DART AEROSPACE LTD	Work Order:	80132
Description: Crosstube Assembly (412 High Aft)	Part Number:	D412-664-243
Inspection Dwg: D412-664-243 Rev: E		Page 1 of 1

DRAWING NO. D412-664-243	TITLE CROSSTUBE ASSEMBLY (412 HI AFT)	REV. E	DART AEROSPACE LTD ENGINEERING ORDER		D.E.O. NO. D412-664-243-E-1	SHEET NO. SHEET 1 OF 2	SCALE NTS
DRAWN	CHECKED	MFG. APPR.	APPROVED	DE APPR.			
DATE 11.03.31	DATE 11/03.31	DATE 11.03.31	DATE 11/03.31	DATE 11.03.31

DRAWING NO. D412-664-243	TITLE CROSSTUBE ASS'Y (412 HI AFT)	REV. E	DART AEROSPACE LTD ENGINEERING ORDER		D.E.O. NO. D412-664-243-E-2	SHEET NO. SHEET 1 OF 1	SCALE NTS
DRAWN <i>q</i>	CHECKED <i>AS</i>	MFG. APPR. <i>ER</i>	APPROVED <i>MP</i>		DE APPR. <i>#</i>		
DATE 11.09.07	DATE 11.09.19	DATE 11.09.19	DATE 11.09.19		DATE 11.09.19

**D412-664-243
ASSEMBLY DETAIL**

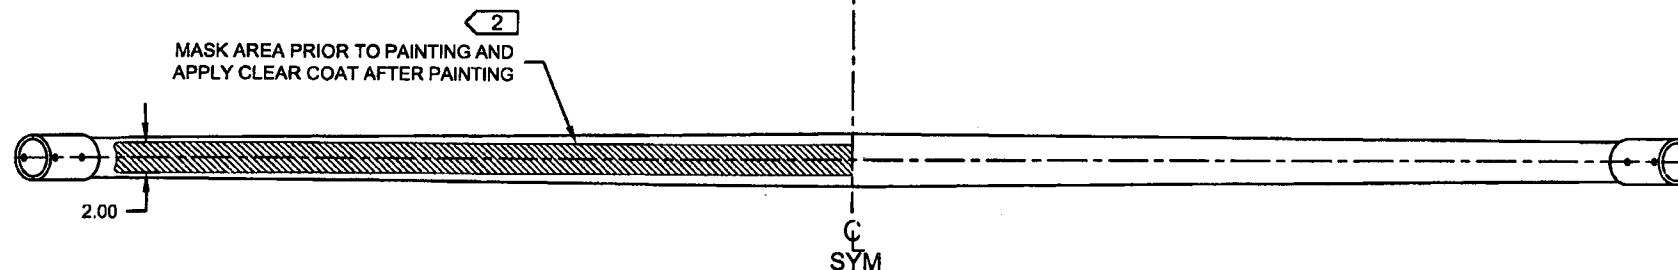
REMOVED ABRASION STRIP IN FAVOR OF A THIN LAYER OF PROSEAL 890.

D3189-1 CHAFING SHIELD (1, INSTALLED OVER PROSEAL 890)
MS21920-28 CLAMP, 2X
2 PL

D2856-600-1009 ABRASION STRIP
D3189-1 CHAFING SHIELD (1, INSTALLED OVER ABRASION STRIP)
MS21920-28 CLAMP, 2X
2 PL
